U.S. DEPARTMENT OF THE INTERIOR
BUREAU OF RECLAMATION
NAVAJO-GALLUP WATER SUPPLY PROJECT
NEW MEXICO

CUTTER LATERAL - REACH 21

BOOSTER PLANT

For Reference Only
DRAFT
Not For Distribution

PLAN-SITE LAYOUT

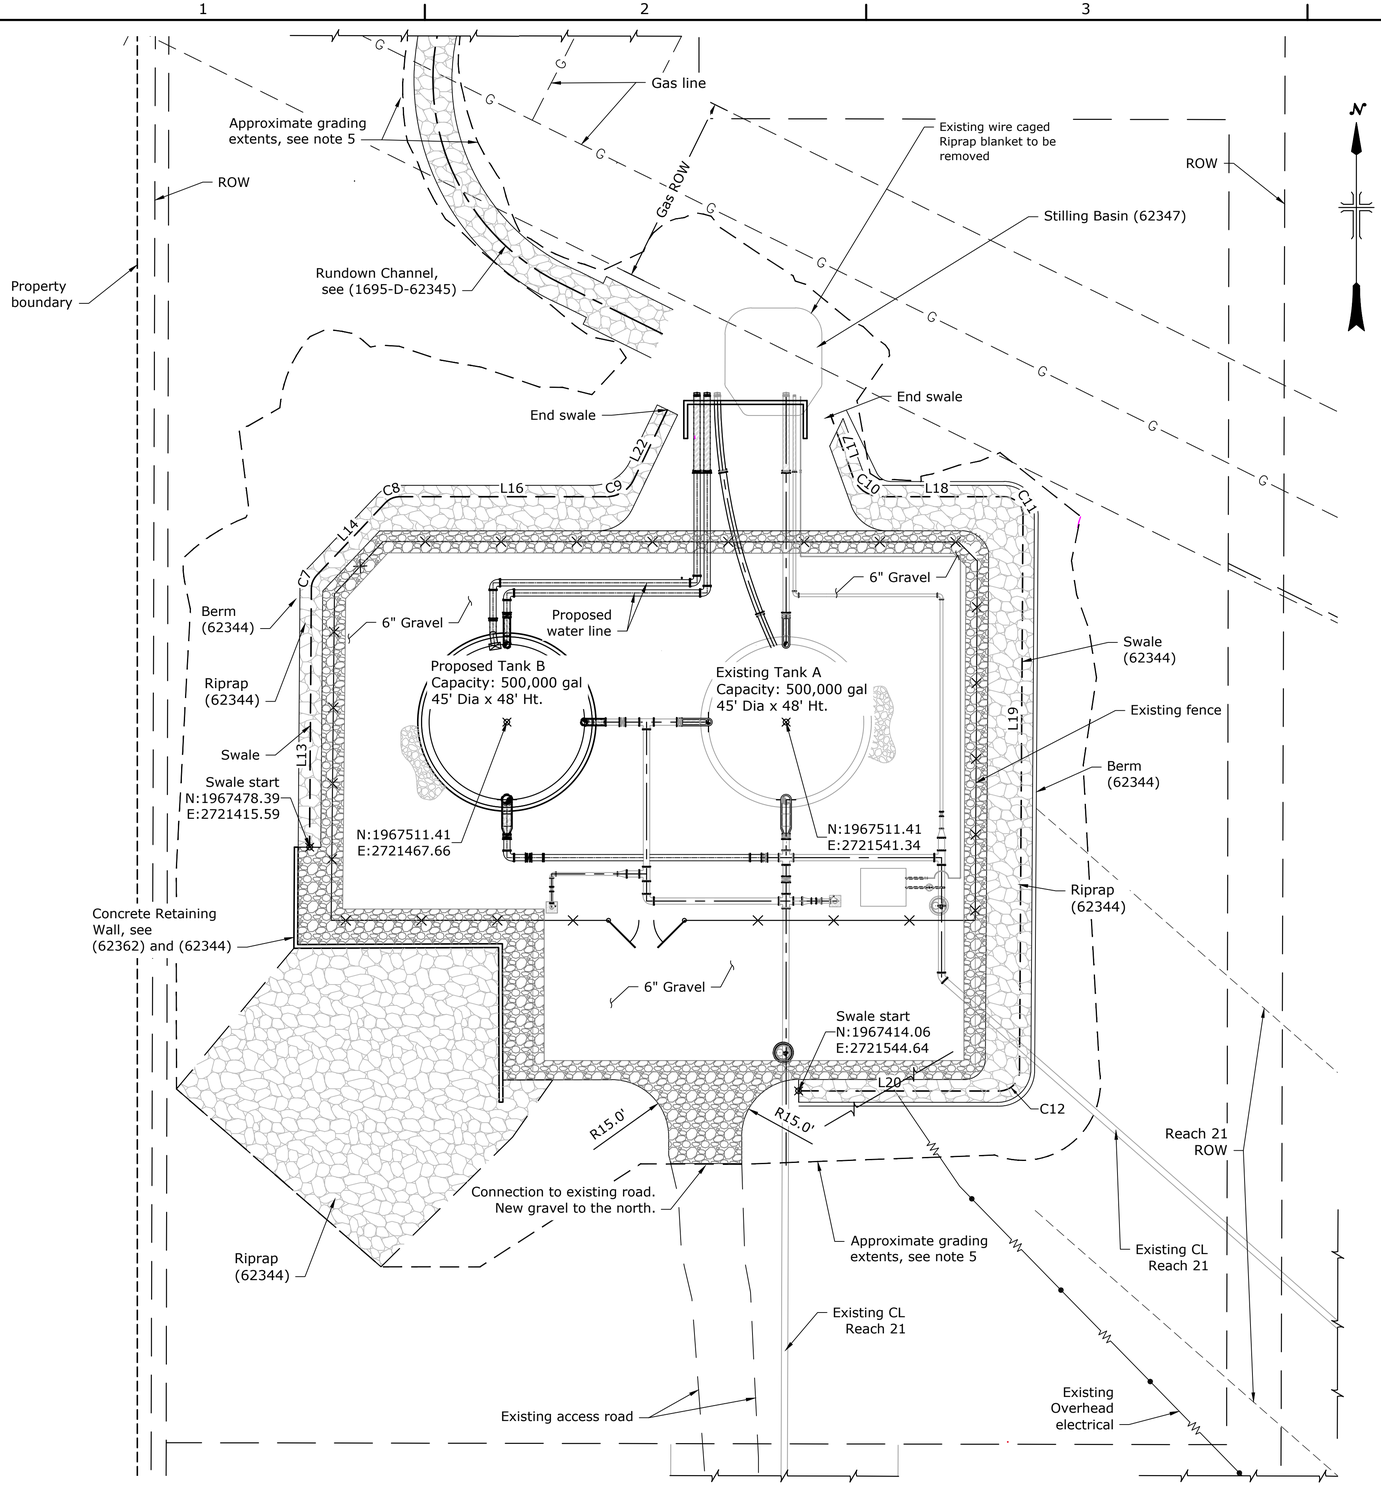
Stilling basin plan shape should be the saem as on sheet 62347

Swale should connect to stilling basin. Stilling basin on 62347 should be added to 62347

Slope Per plan

Finished grade slope per plan

Riprap swale, slope per plan

Note 2. Change from 4:1 to 6:1.
Note 6 Add geomembrane

Add coir wattles at the mid-point and toe of all tank site sideslopes. Need to add installation details. I think NGWSP 4A and 4B has the latest drawings.
